City Planning Commission
Sacramento, California

Subject: Various requests for NE corner of Riverside Blvd. & Bay
River Way & NE & NW corner of Bay River Way & Big River Ct.

- APPLICATION:**
- A. Ratify Negative Declaration
 - B. Rezone 3 vacant corner lots totaling 0.4 acres from Single Family (R-1) to Townhouse (R-1A) zone (Zoning Ord., Sec. 7)
 - C. Tentative Parcel Map to subdivide 3 existing corner lots into six halfplex lots (Sub. Ord., Chapter 40)
 - D. Special Permit to develop 6 halfplexes (Zoning Ord., Sec. 7)

PROPOSAL: The applicant is requesting the necessary entitlements to develop six halfplex units on three corner lots in the Riverwind Subdivision.

site plan

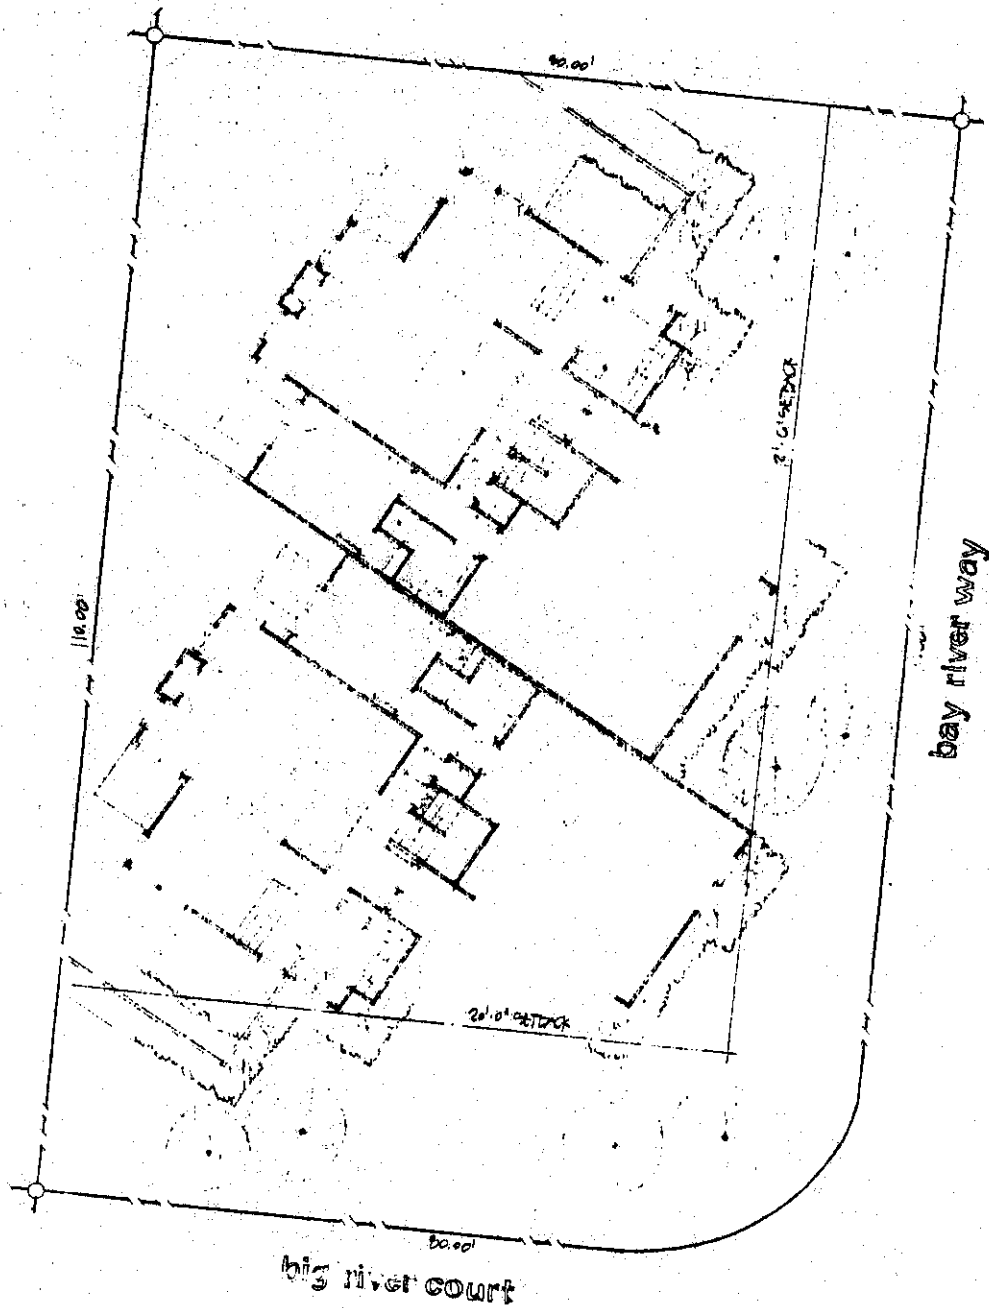
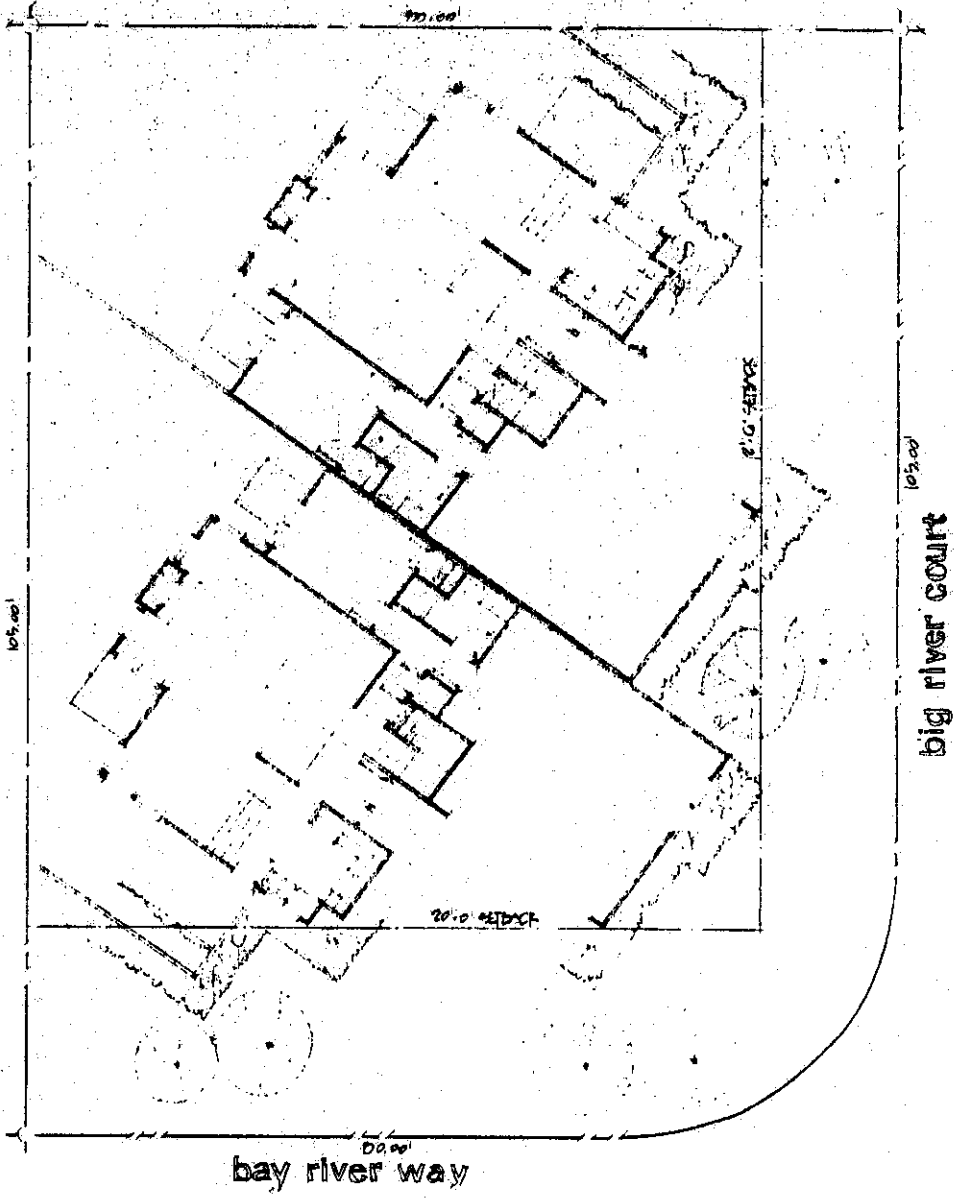
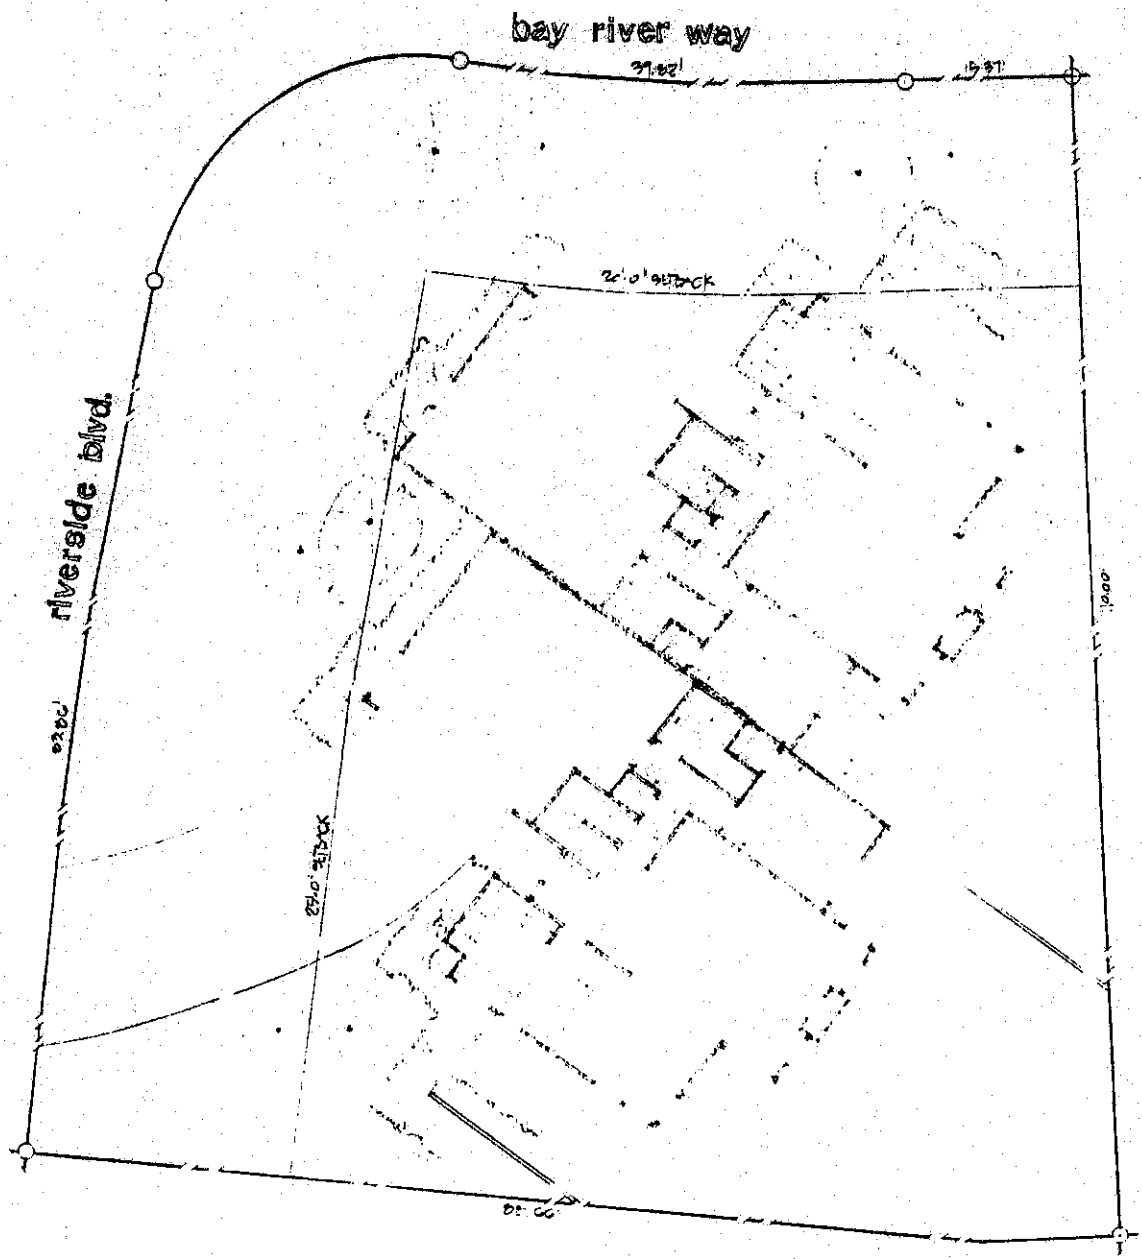
2. The applicant proposes to locate each structure at a diagonal angle on the lot. Under the R-1A zone, which allows flexibility regarding building setbacks, the front yard setback is proposed at 20 feet rather than the standard 25 foot setback under the R-1 zone. The front yard setback for all existing homes adjacent to the three proposed structures is 25 feet. Staff, however, does not necessarily oppose the proposed 20-foot building setback, based upon the design and diagonal placement of the structures on each lot. The front and side elevations of each structure contain many offset planes which tend to present an interesting facade from street view rather than the typical flat plane facade of most typical halfplexes. Due to these offsets and diagonal placement of the structure on the lot, only the corner of the kitchen and corner of the garage project into the standard 25-foot front yard setback area. The remainder of the front building plane is recessed behind the proposed 20-foot front yard setback.

In addition, the front of the garage is located at an angle to each street which reduces the visual impact of a large garage door from the street perspective. From the street corner, one would be viewing the sides of the two garages rather than the garage doors.

All three structures will adhere to the minimum 12½ foot street side yard setback.

The only modifications requested by staff relative to the site plan is that the six-foot high fence proposed to extend beyond the 20-foot front yard setback be held back at the 20-foot setback line, and that all curved driveways turn 90° at the sidewalk and maintain a minimum 20-foot distance between the front of the garage and property line at the closest point.

1. The primary exterior building materials of all three structures shall consist of horizontal wood siding and wooden shake roofs.
2. The six-foot high patio fence proposed in the front yard setback area shall be set back 20 feet from the front property line.
3. The distance of all driveways between the front of the garage and front and street side property lines at the closest points shall be a minimum 20 feet. The curved driveways shall be modified to turn at a 90° angle to the sidewalk.
4. Revised plans indicating the above items shall be submitted to staff for review and approval prior to issuance of building permits.
